ANN ARBOR PLANNING DEPARTMENT STAFF REPORT

For Planning Commission Meeting of September 19, 2017

**SUBJECT: Weber Site Plan (2857 Packard Road)
File No. SP17-004**

SUBJECT: **Site Plan:** 2857 Packard
Location: 2857 Packard
Plans Dated: July 14, 2017
Project Number: SP 17-004

SITE ALTERNATIVE COMPARISON CHART

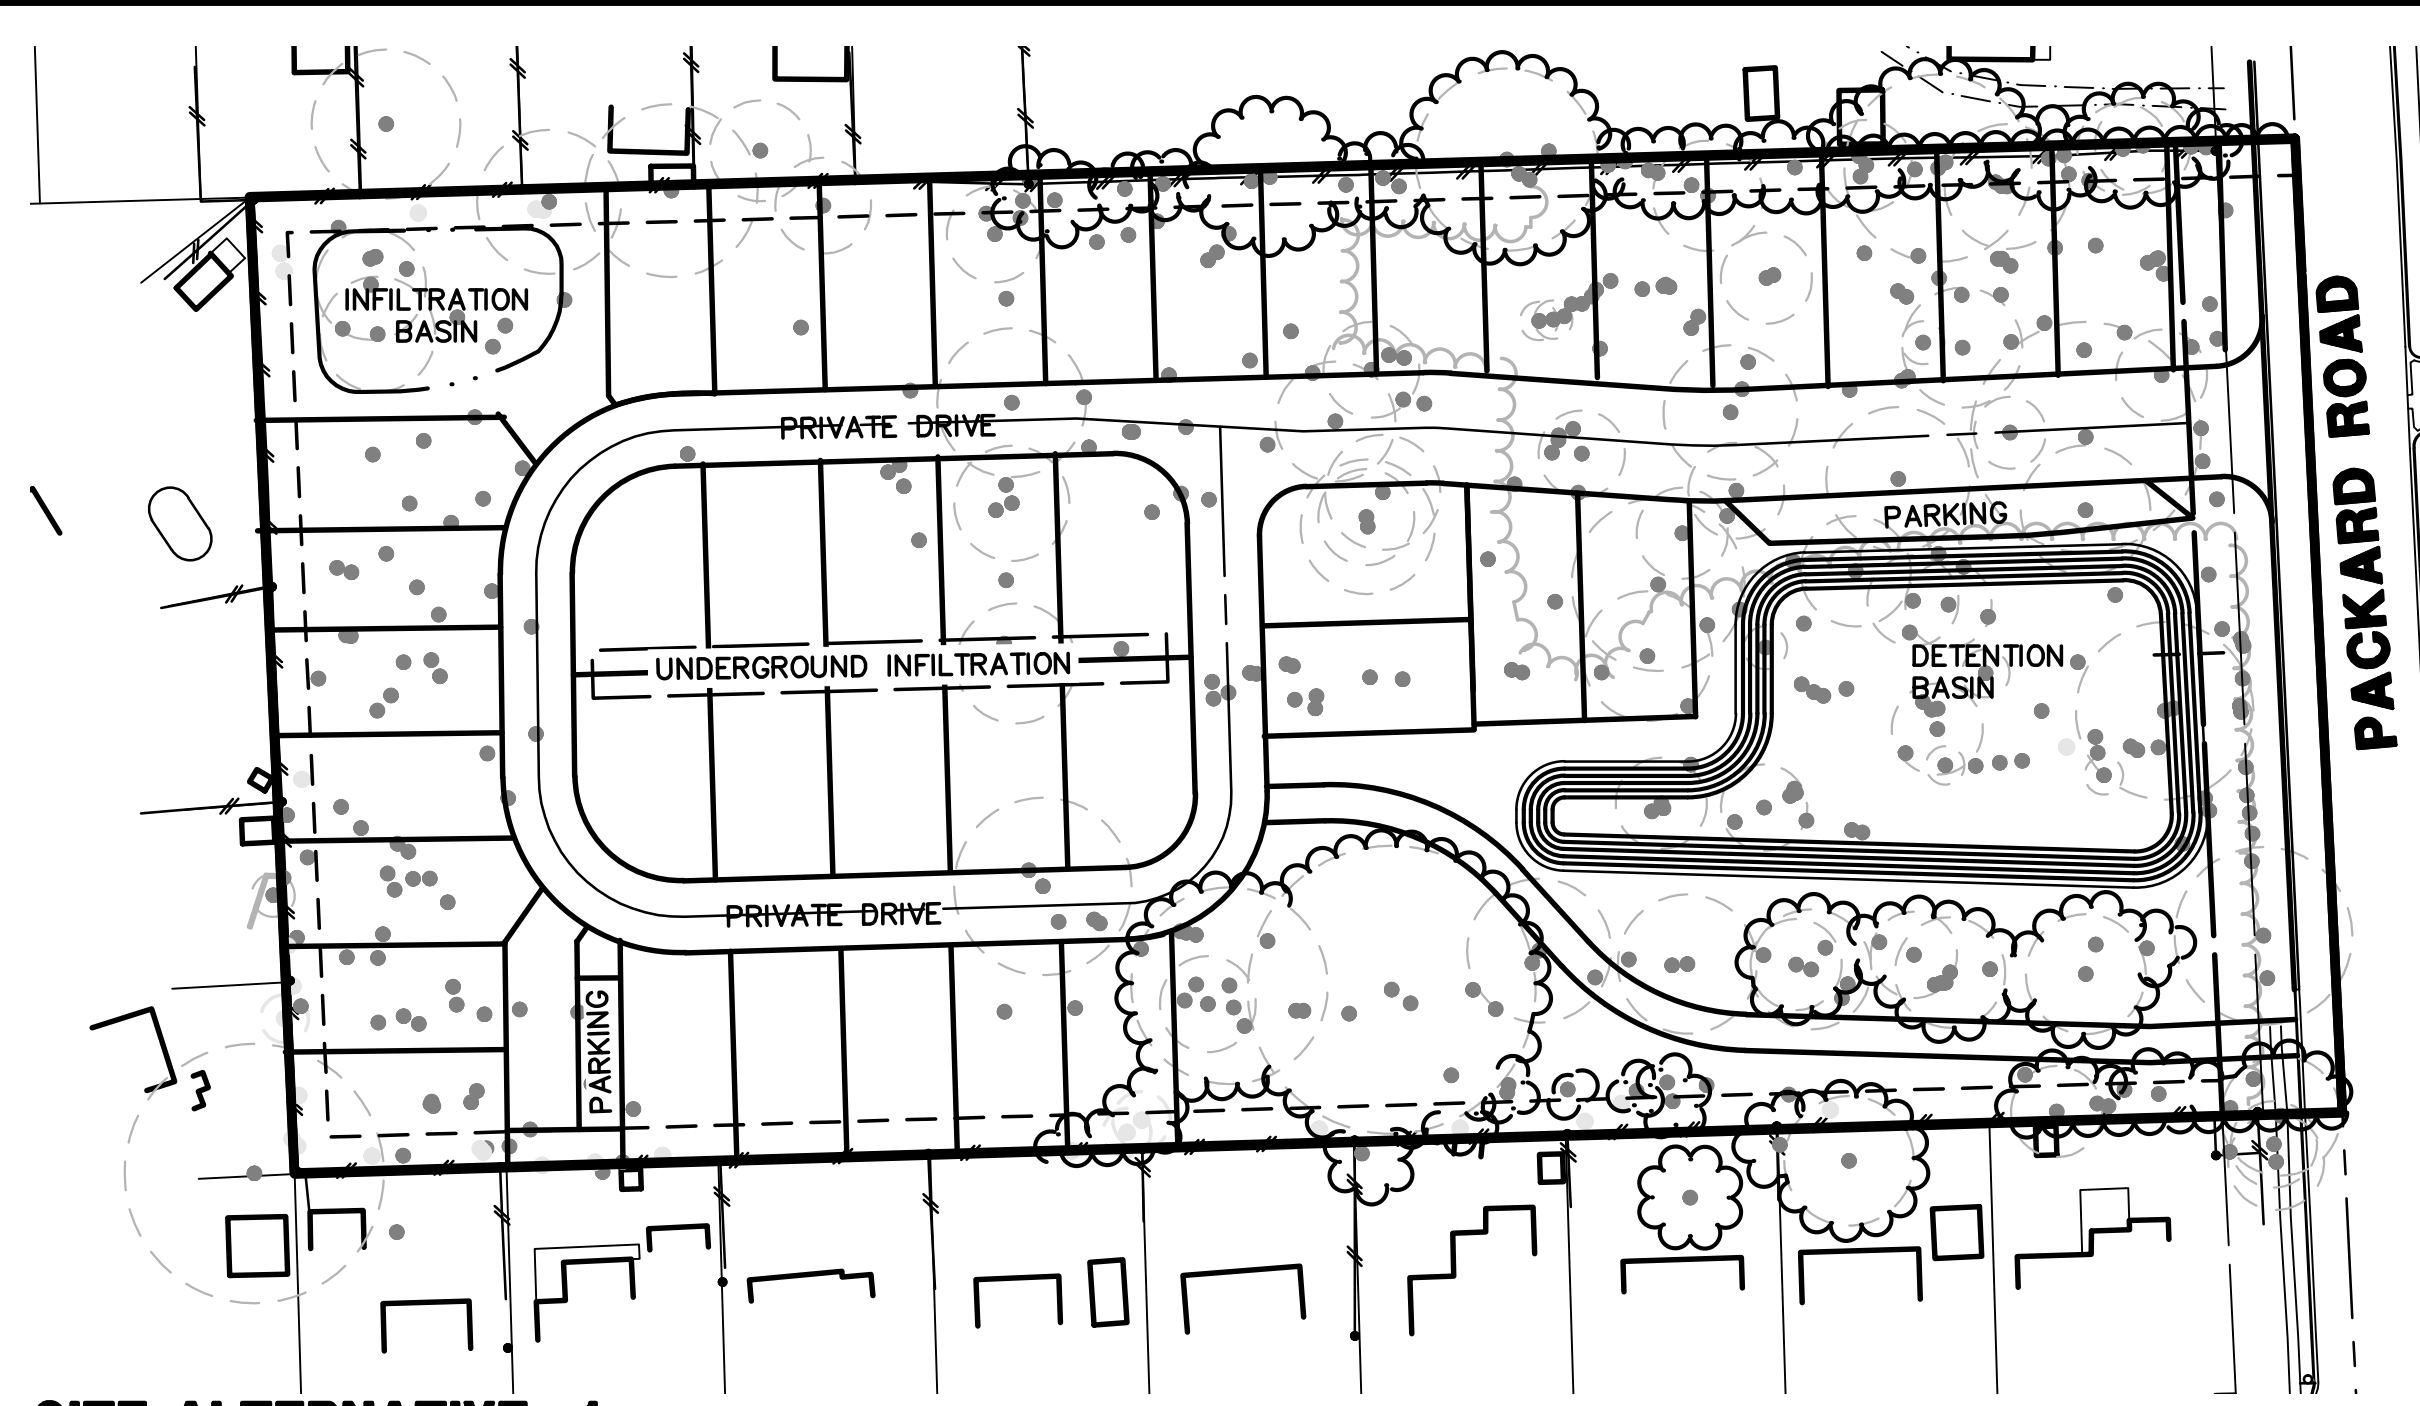
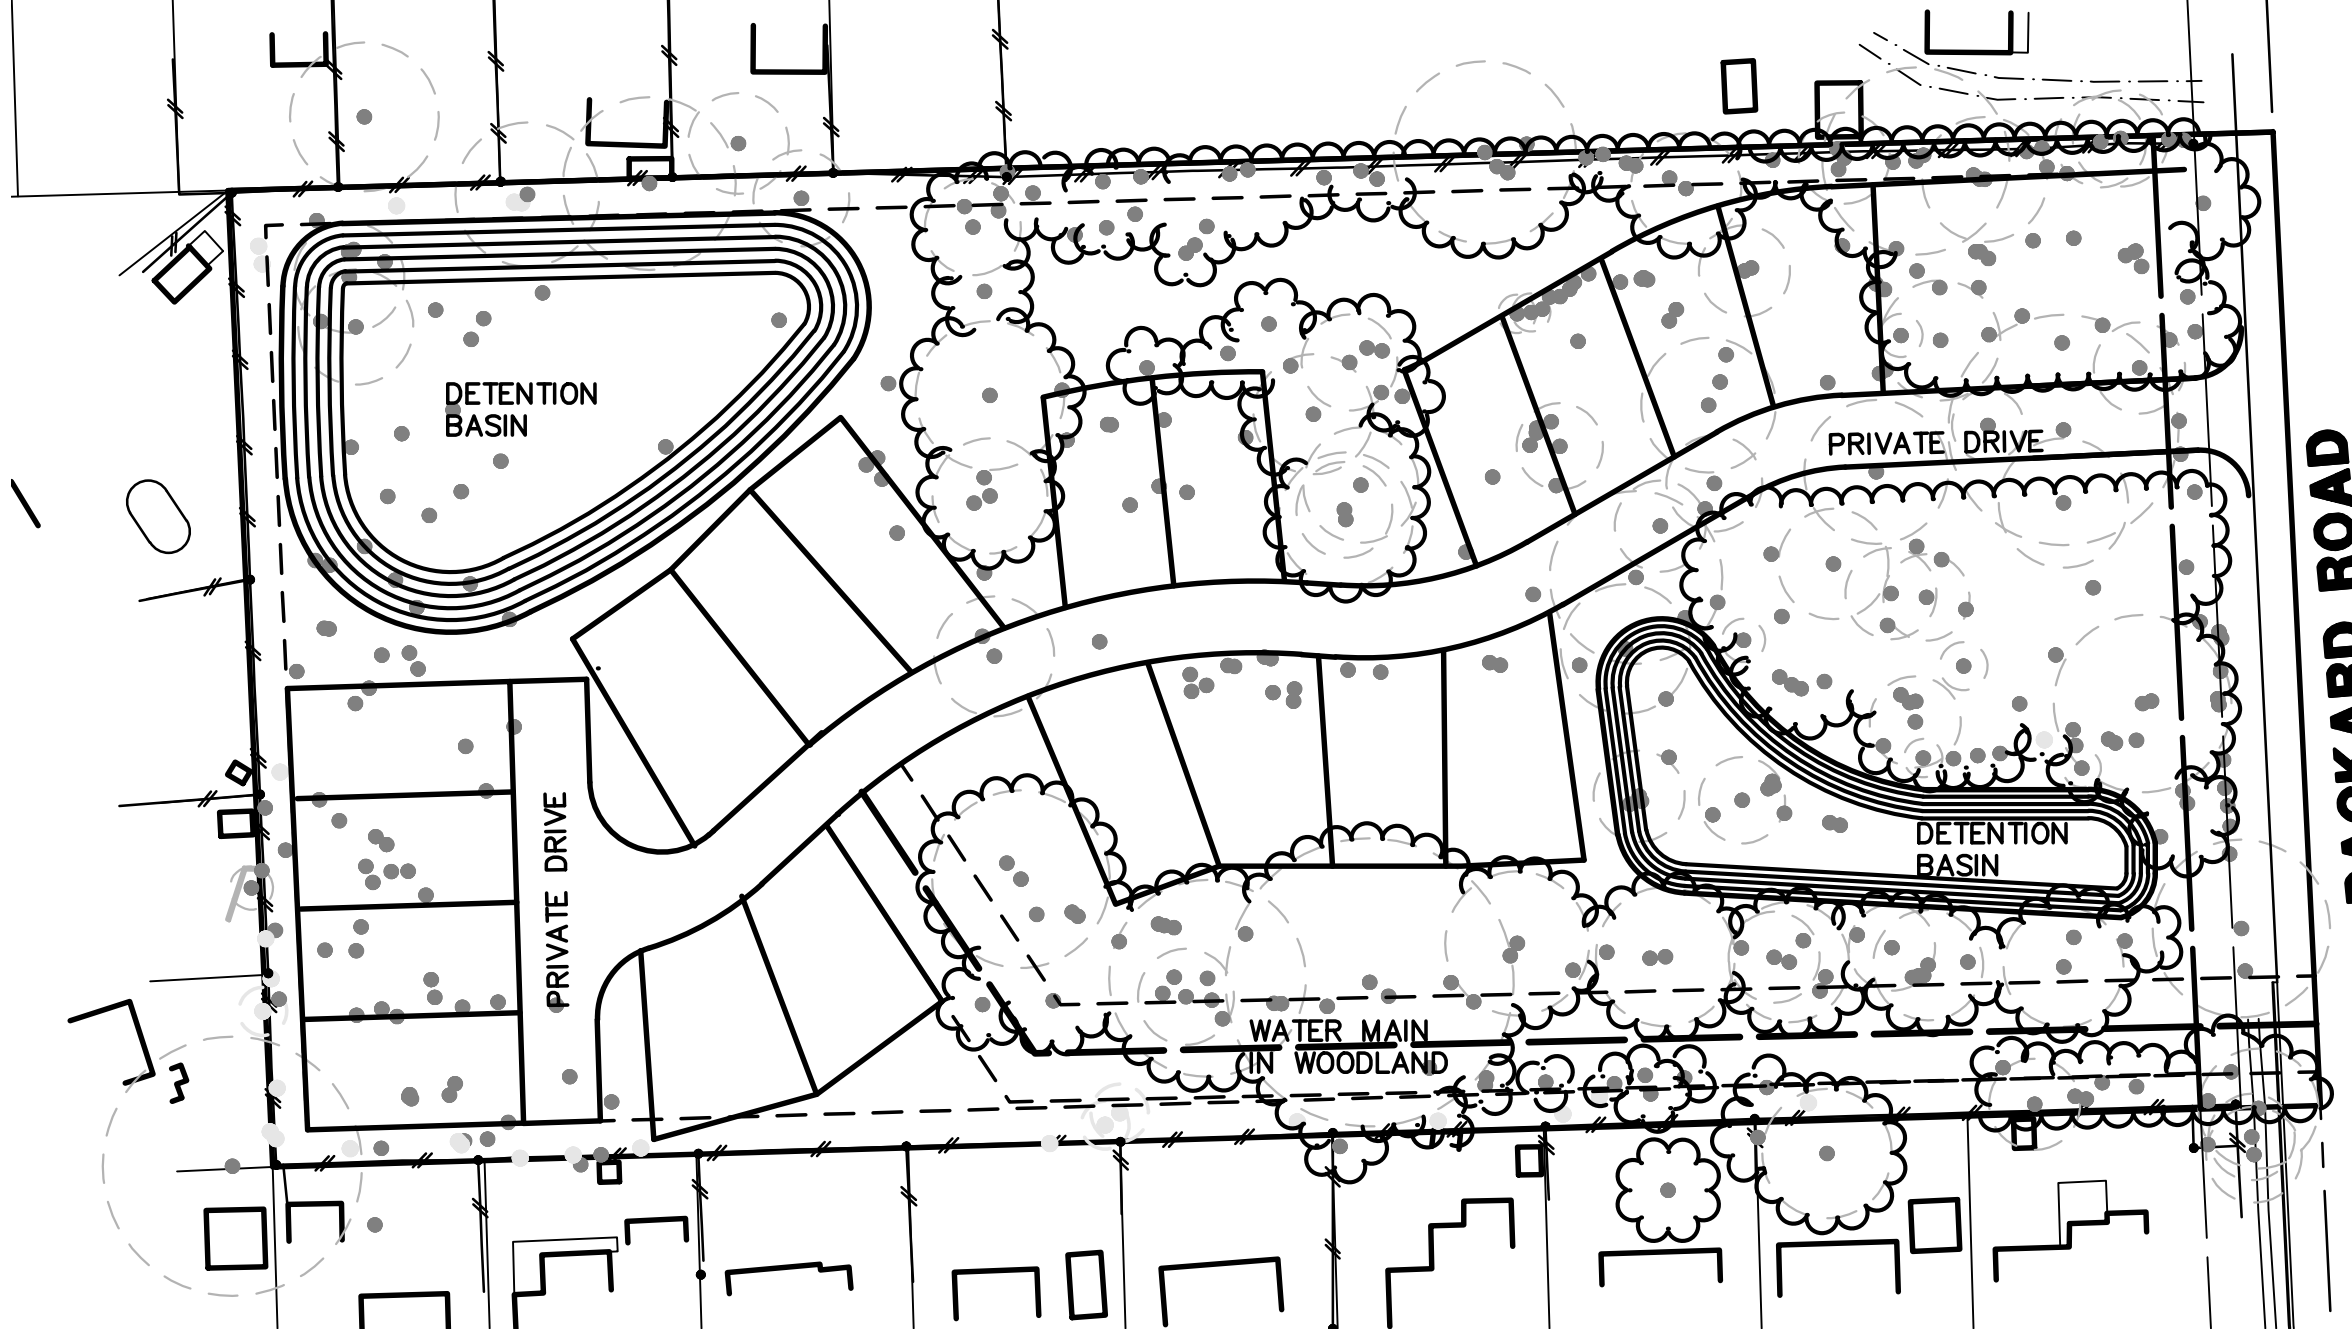
The petitioner provided alternative analysis showing fewer lots with more natural features preservation. Site Alternative #1 contains 40 lots and preserving additional natural features. While there are many constraints on site, any proposed development should be concentrated on the northern three-quarters portion of this site. This demonstrates an alternative plan that provides for a reasonable use of the property, with less impact to natural features.

3. The committee discussed that several of the proposed alternative layouts, presented in the plan set, would preserve more natural features and would allow for a more efficient and effective stormwater management system. These alternative layouts are preferable to the extent that they minimize the natural features impact and lessen the stormwater impacts of this development.
